CH6, Sec2, 1.4.2

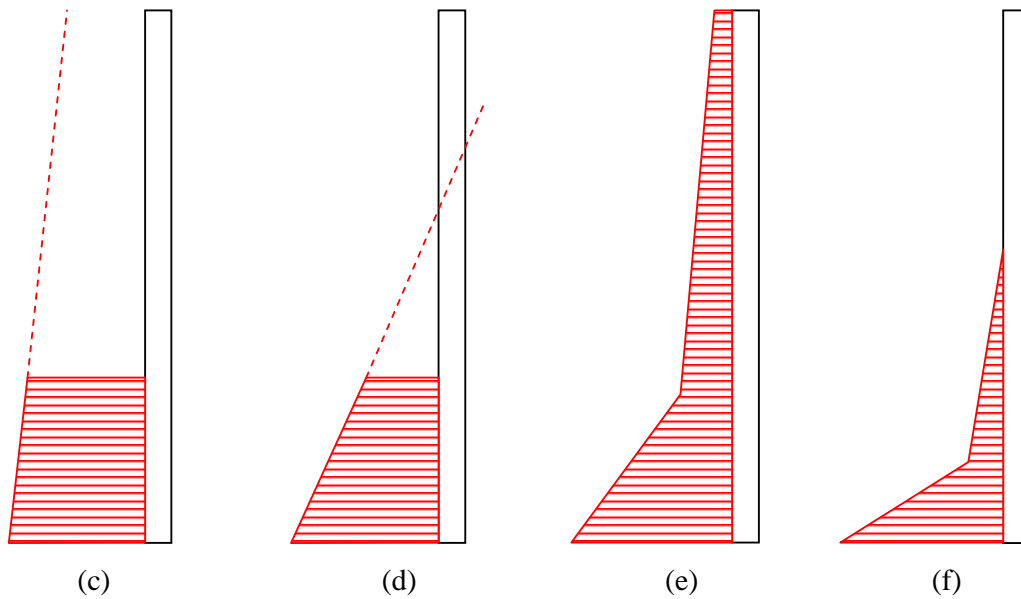
The formulae in this paragraph derive the pressure p for two cases:

- (a) The stiffener is loaded with pressure over the whole height
- (b) The stiffener is loaded with pressure only in a part of its height

Both cases are valid under the assumption, that the slope of the pressure curve is constant.

In case of structure, loaded from both sides the following additional pressure distributions are possible.

How to calculate the pressure p , used in CH6, Sec2, 3.2.3 for examples (c) to (f)?
